**MONTGOMERY COUNTY HISTORIC PRESERVATION COMMISSION**  
**STAFF REPORT**

<b>Address:</b>	26 Oxford St., Chevy Chase	<b>Meeting Date:</b>	2/27/2019
<b>Resource:</b>	Non-Contributing Resource <b>Chevy Chase Village Historic District</b>	<b>Report Date:</b>	2/20/2019
<b>Applicant:</b>	Gerstenfield/Wiltshire	<b>Public Notice:</b>	2/13/2019
<b>Review:</b>	HAWP	<b>Tax Credit:</b>	partial
<b>Case Number:</b>	35/13-19D	<b>Staff:</b>	Dan Bruechert
<b>Proposal:</b>	Demolition and Building Addition and Tree Removal

Staff recommends that the HPC approve with one (1) condition the HAWP application.

WILTSHIRE RESIDENCE      EXISTING SITE PLAN      1"=20'

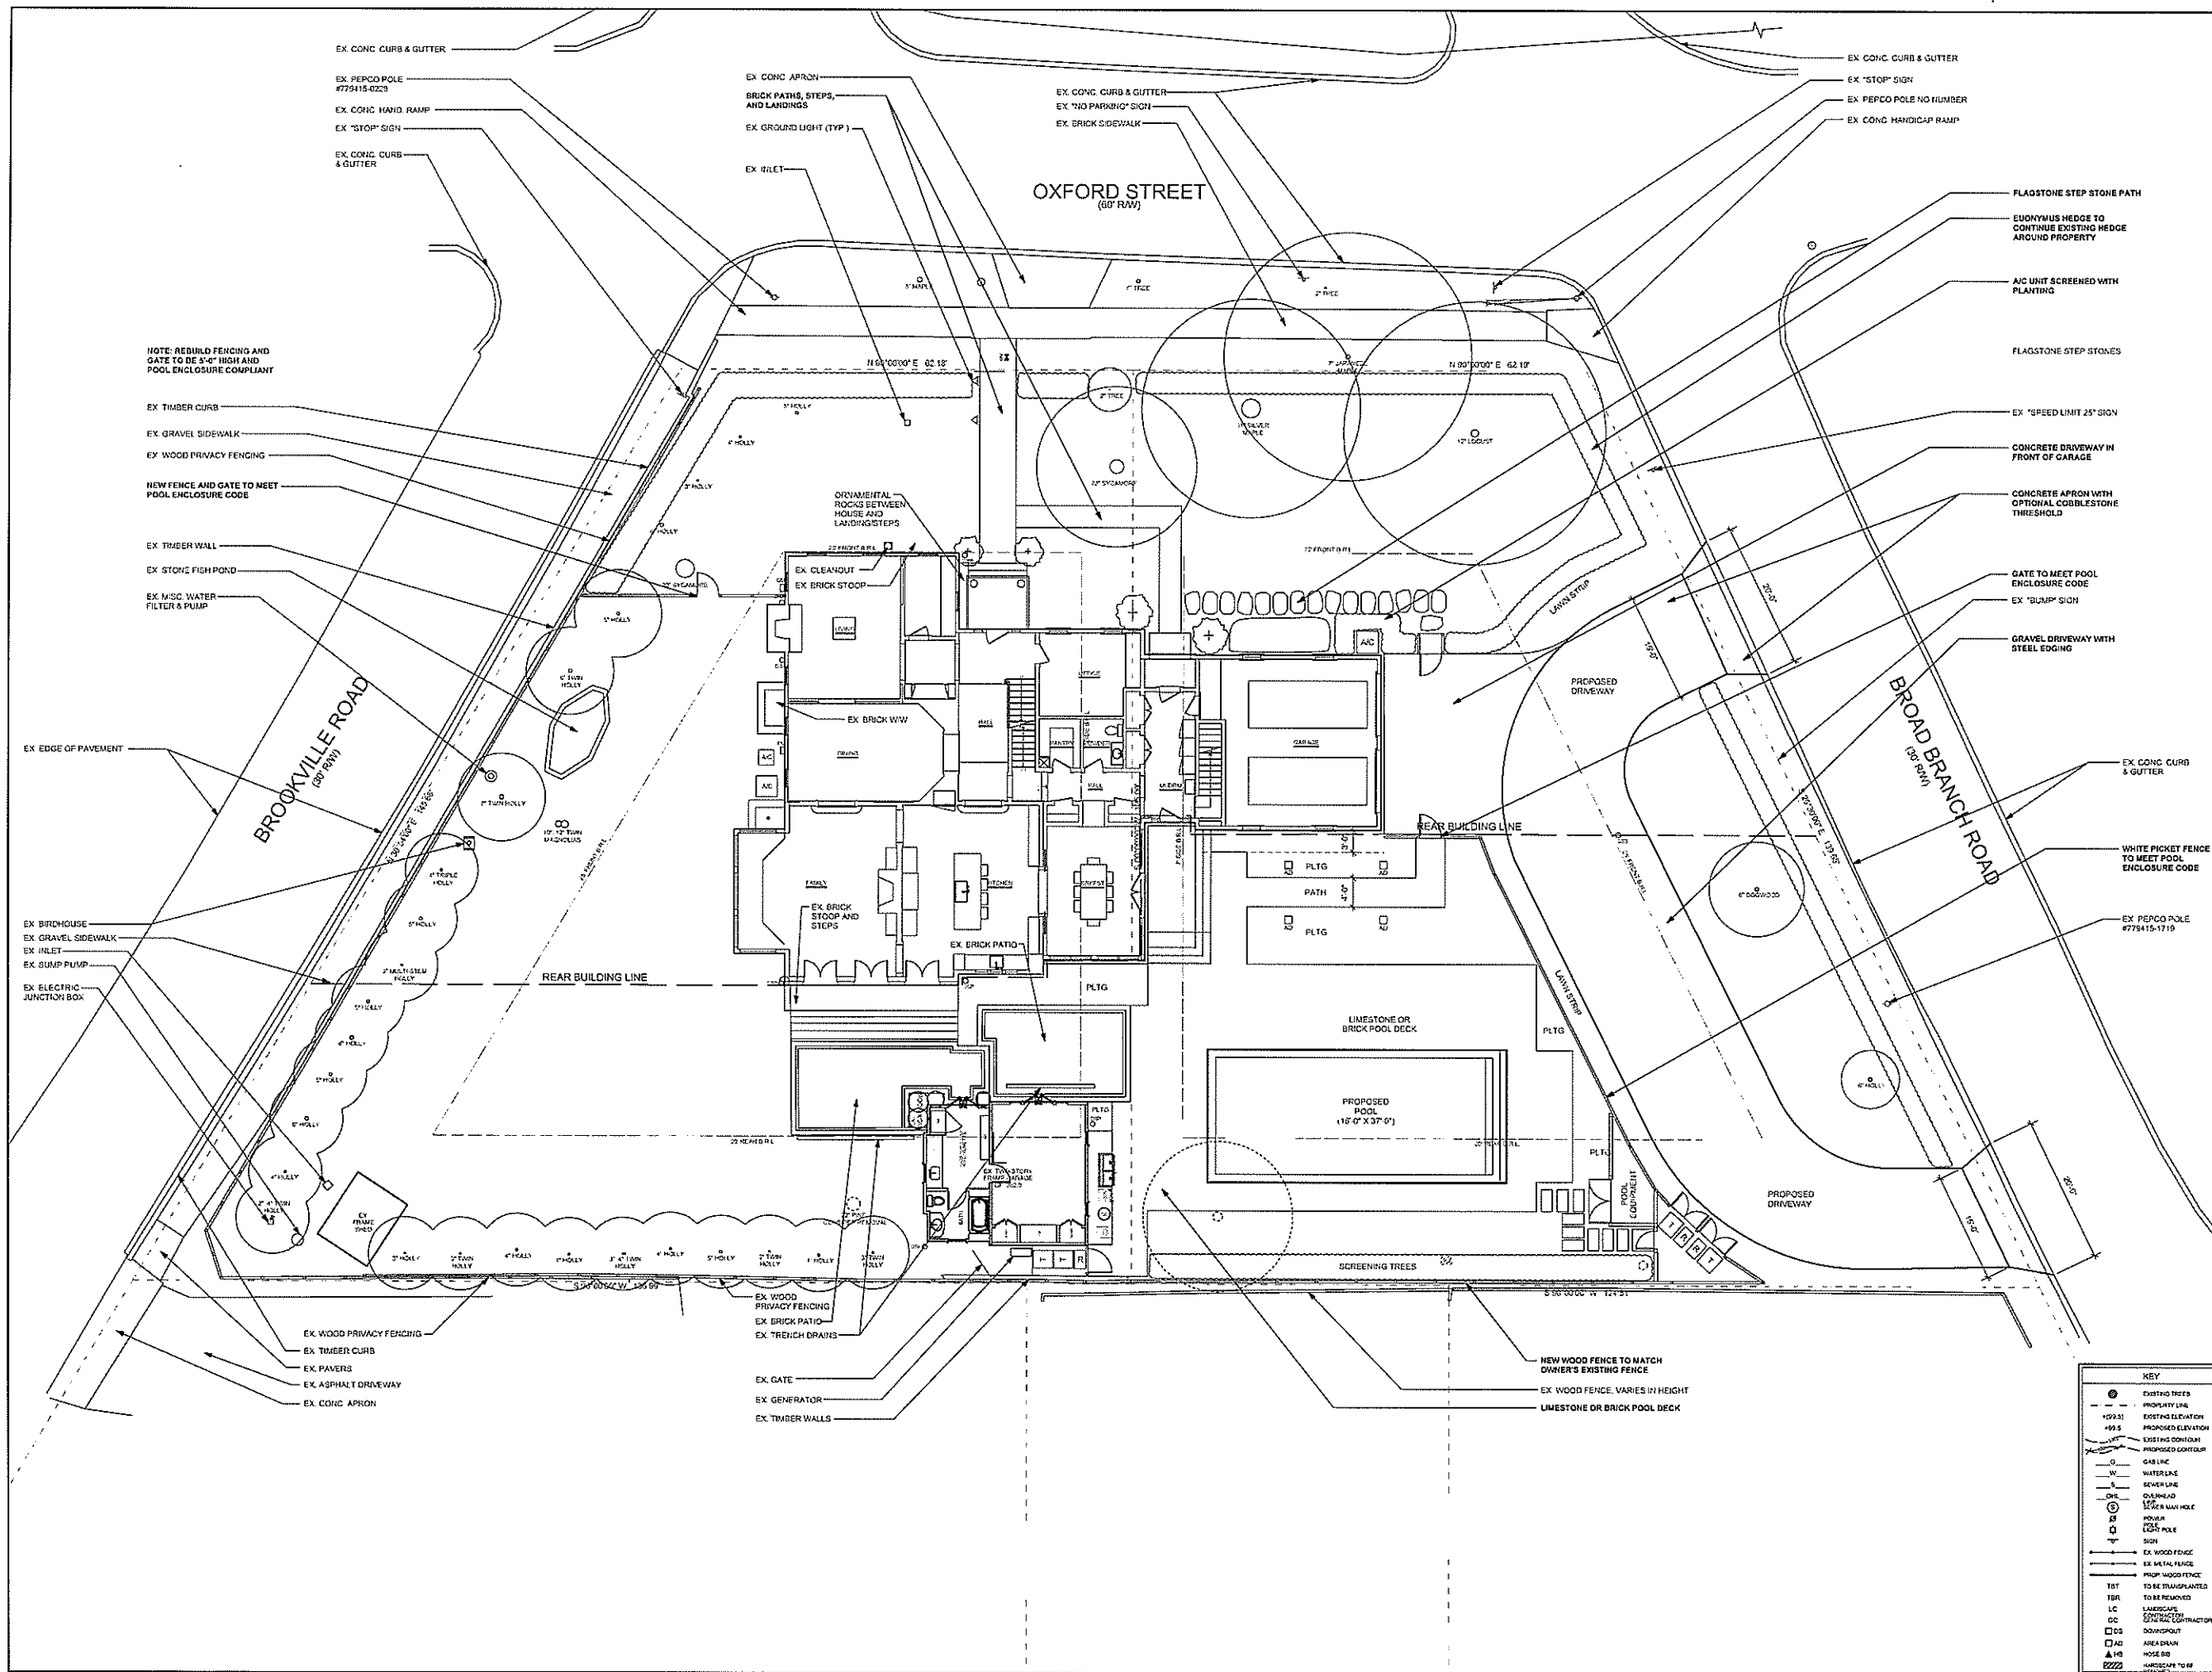
There are several mature trees on Lot 7 as identified on the "Existing Site Plan." The applicant proposes to remove a 27" (twenty-seven inch) d.b.h. Sycamore tree that is to the east of the house. This tree is in the location of the proposed addition. This tree is located several feet behind a 29" (twenty-nine inch) d.b.h. sycamore tree. In evaluating this proposal under strict scrutiny, Staff finds that the proposal will have an impact on the lot and surrounding canopy; however, Staff supports removal for three primary reasons. First, the larger sycamore tree between the house and the street obscures the view of the tree to be removed. Second, the denial of this tree removal would frustrate the purpose of this HAWP and the larger work proposed. Finally, Staff does not find that the loss of this tree would significantly alter the tree canopy of the site and surrounding district and recommends approval of the tree removal.
